April 1, 2008

TENTATIVE WASTE DISCHARGE REQUIREMENTS AND NATIONAL POLLUTANT DISCHARGE ELIMINATION SYSTEM (NPDES) PERMIT – CITY OF OXNARD WASTEWATER TREATMENT PLANT (NPDES PERMIT No. CA0054097, CI NO. 2022)

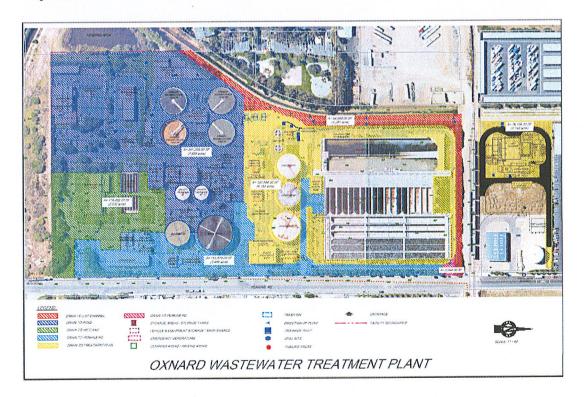
Page F-5, item 2.A.2, *Description of Wastewater and Biosolids Treatment or Control*, states that "All of the storm water runoff traversing the treatment areas of the Facility premises is captured and treated in the plant." With the construction of our new Headworks facility this year north of the main treatment area, this statement is no longer valid, and we are currently developing a stormwater plan for the entire treatment plant. The areas of the plant have been divided for implementation of the plan as shown in the map transmitted to staff earlier this month:

The treatment plant stormwater program is now implemented under the Municipal Stormwater Permit for Ventura County. The inclusion of stormwater requirements in the tentative NPDES permit for the WWTP is now duplicative, and we request that these requirements be eliminated from the draft. These requirements are covered under item e. *Activities Coordination*, on page 37 of the Order.

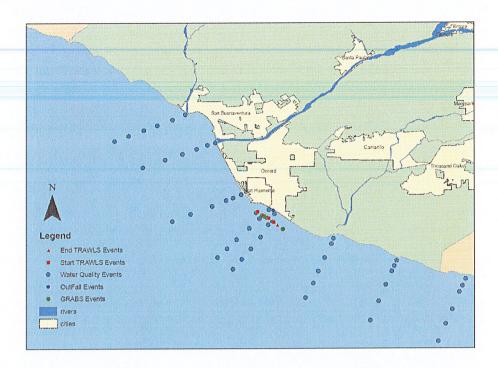
Page F-34, *Receiving Water Monitoring*, starts the discussion of surface water monitoring, including core monitoring (local), regional monitoring (participation in Southern California Coastal Water Research Project (SCCWRP) bight-wide monitoring), and special studies. Historically, our core monitoring (i.e., quarterly ocean monitoring) has consisted of the following stations:

As this monitoring is regional in nature, and measures the impacts to ocean water quality from a variety of diverse sources, we request that the core monitoring program be limited to identifying the impacts from the discharge on ocean water quality in the vicinity of the discharge. This will become increasingly important if other ocean outfalls are approved in proximity to the existing City of Oxnard Discharge Point 001. The scale of monitoring could then be expanded again under Bight '08 and future Bight efforts under SCCWRP.
